Project	Project description	Scale	Job No
233 Uxbridge High St	New banqueting hall and Hotel	1:100@A1	0242
Title	Stage	Drawing No	Rev
West Elevation	Planning	A212	01

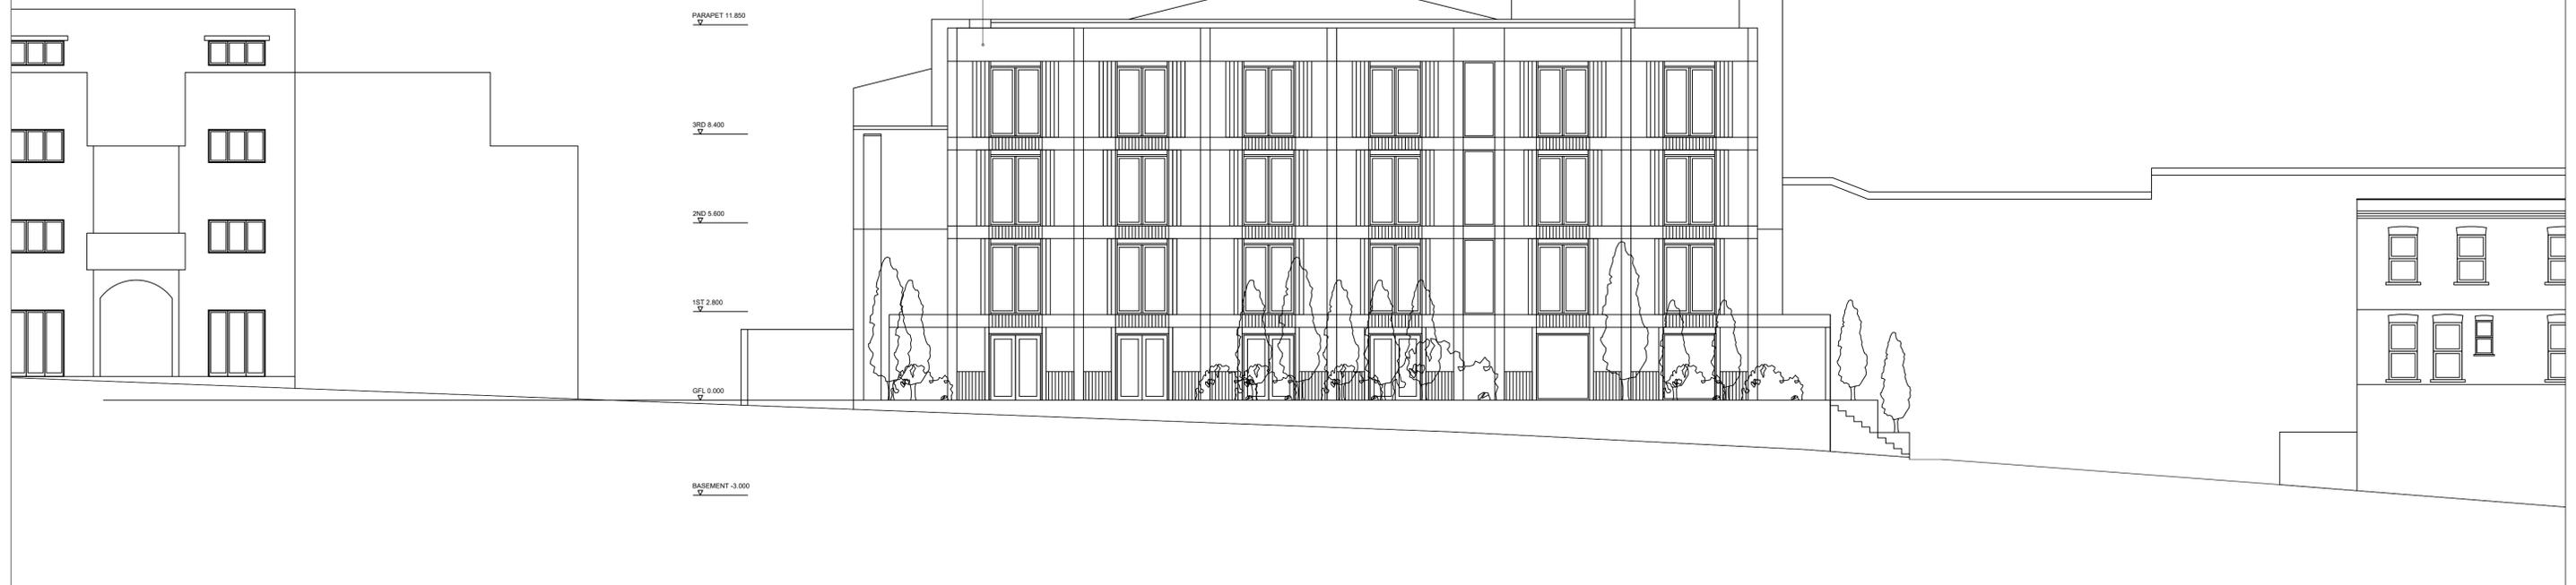
1. Basement redesigned and access flipped as requested. Access is via road at Cumbrian way.
2. Ramp has been removed and a car lift proposed. This offers more space in the basement and better turning capacity. In addition the ramp access has been removed from the front elevation.
3. Trees shown for BNG.
4. Hotel rooms revised to be Part M compliant.
5. Lift to frontages of hotel and listed building.
6. Soft landscaping and terracing to front of hotel.
7. Pathways and alley improved with landscaping.
8. Oriel windows added to the southern elevation to mitigate overlooking.
9. Low energy systems added to roof.
10. Window head detailing added.
